UNITED STATES PATENT AND TRADEMARK OFFICE

APPLICATION NO.	FILING DATE	FIRST NAMED INVENTOR	ATTORNEY DOCKET NO.	CONFIRMATION NO.
09/916,364	07/27/2001	Gary Curtis Gehrke	403	7594
2292	7590	05/18/2004		
BIRCH STEWART KOLASCH & BIRCH PO BOX 747 FALLS CHURCH, VA 22040-0747			EXAMINER DUVERNE, JEAN F	
			ART UNIT 2839	PAPER NUMBER

Office Action Summary

DETAILED ACTION

Attachment 1

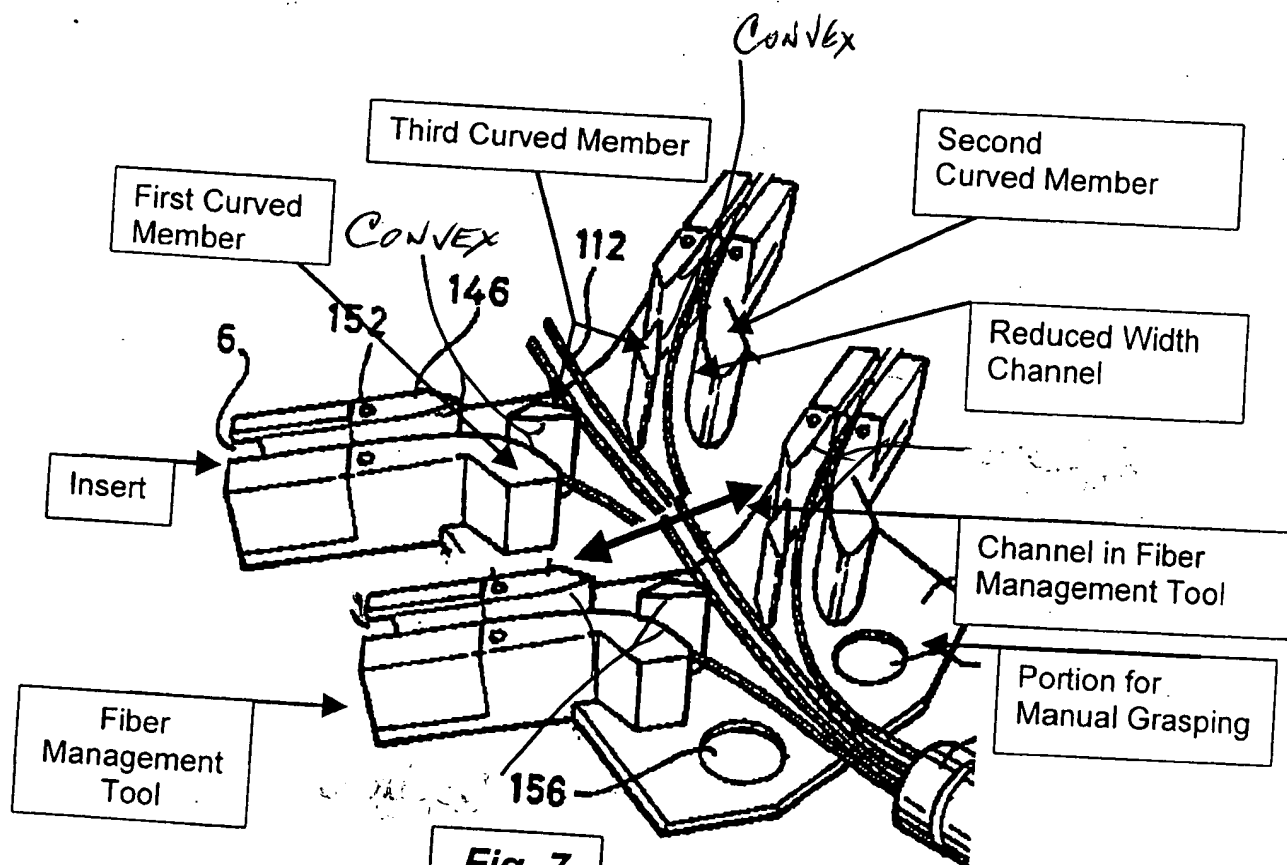
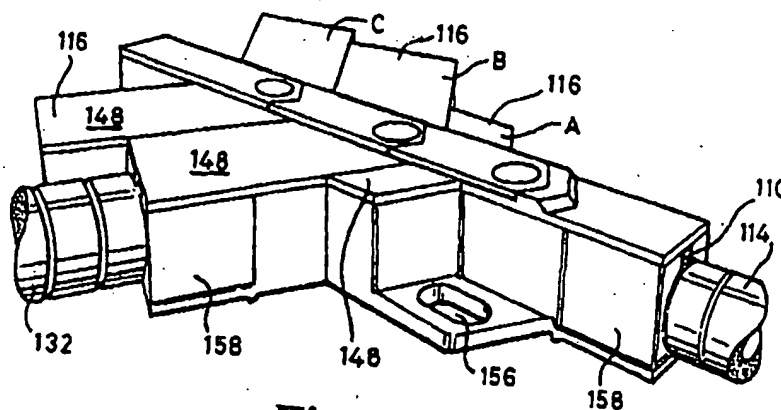
Stockman et al discloses, in figures 1-7 (see Attachment 1), an insert removably provided within a fiber optic cable management tool comprising:

- a fiber optic cable management tool
- at least one arcuate portion on said fiber optic cable management tool
- a first curved member on said insert having a first curved portion and a second curved portion
- a second curved member on said insert having a first curved portion and a second curved portion
- a third curved member on said insert having a first curved portion and a second curved portion
- said first, second, and third curved members being formed integrally
- a channel formed between the second curved portion of the first curved member and the first curved portion of the third curved member
- a channel formed between the second curved portion of the second curved

- a channel formed between the curved member and the at least one arcuate portion
- all said curved portions and said channels having a radius that exceeds the minimum bend radius of a fiber optic cable having a diameter less than or equal to 1.7 millimeters (column 1, line 64 - column 2, line 32)
- said channel having a smaller width than a channel provided in the fiber optic cable management tool
- at least one curved member (the third) having first, second, and third curved portions
- a portion on the fiber optic management tool that permits manual grasping (see Attachment 1).

However, Stockman's device fails to explicitly concave shape for the arcuate portion of the tool management or the convex-shaped curved portion for the curved member. It would have been obvious to one having ordinary skill in the time the invention was made to have the arcuate portion of the tool management with the concave shape and the curved member with the convex-shaped, since such a modification would have involved a mere change in shape of a component. A change in shape is generally recognized as being within the level of ordinary skill in the art. In re Dailey, 149 USPQ 47 (CCPA 1976).

features that distinguish over prior art: For example, Stockman et al discloses, in figures 1-7 (see Attachment 1), an insert removably provided within a fiber optic cable management tool comprising: a fiber optic cable management tool; at least one arcuate portion on said fiber optic cable management tool a first curved member on said insert having a first curved portion as stated above. The concave shape for the arcuate portion of the tool management or the convex-shaped curved portion for the curved member as amendment added to the claims is not enough to put claims in condition for allowance (see the above rejection). Accordingly, **THIS ACTION IS MADE FINAL**. See MPEP 706.07(a). Applicant is reminded of the extension of time policy as set forth in 37 CFR 1.136(a).
